Working to Perfect the Flow of Energy

Section 11: Generator Data Confidentiality Procedures

11.1.4 Generator Data Process Flow

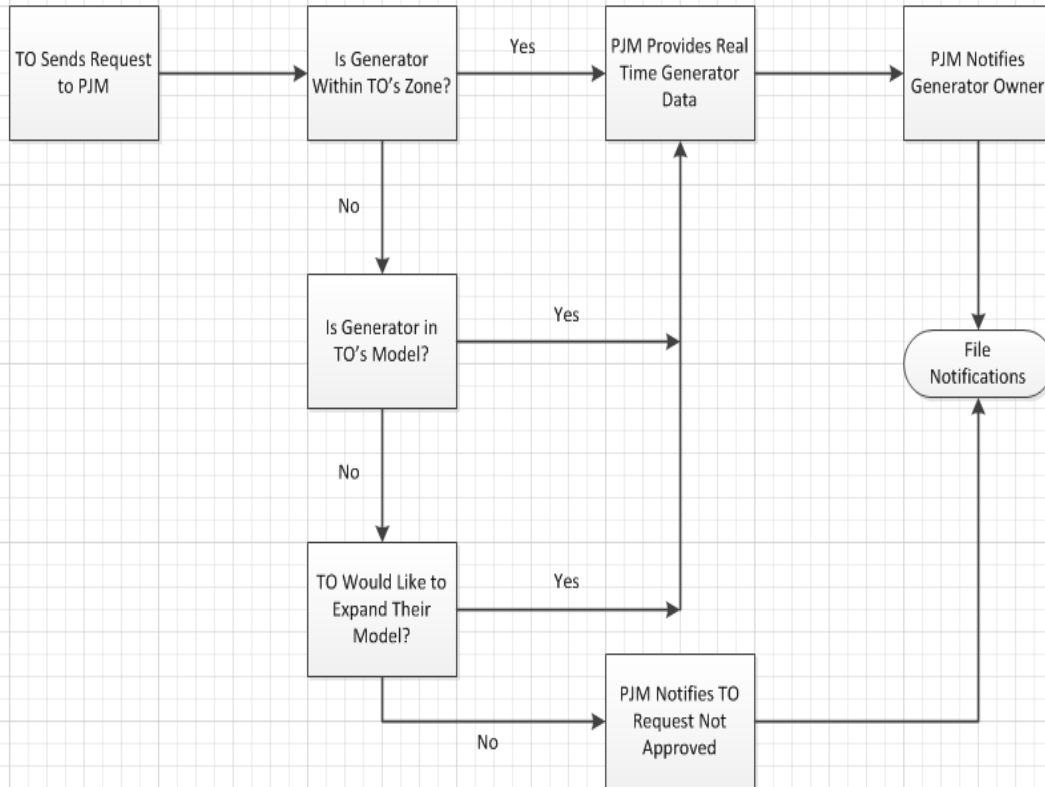
~~Exhibit 14: Process to Approve Scheduled Outage Data Request—Decision Points with Definitions~~

~~11.1.5 Executing a Data Confidentiality Agreement~~

~~After evaluating the applicability of the data request with the above decision points, the Transmission Owner initiates a Data Confidentiality Agreement with each Generator Owner. An officer of the Transmission Owner signs three copies of the Generator Data Confidentiality Agreement and submits them to the Manager of the PJM Generation Department. When initiating the Agreement, the PJM Generator Member Company name on record with PJM needs to be inserted into the beginning of the Agreement by the Transmission Owner. Any questions about the official Member Company name should be directed to the Manager of the PJM Generation Department. The Agreement can be found in Attachment I of this manual. (An electronic version of the Generator Data Confidentiality agreement is also available from the Manager of the PJM Generation Department.)~~
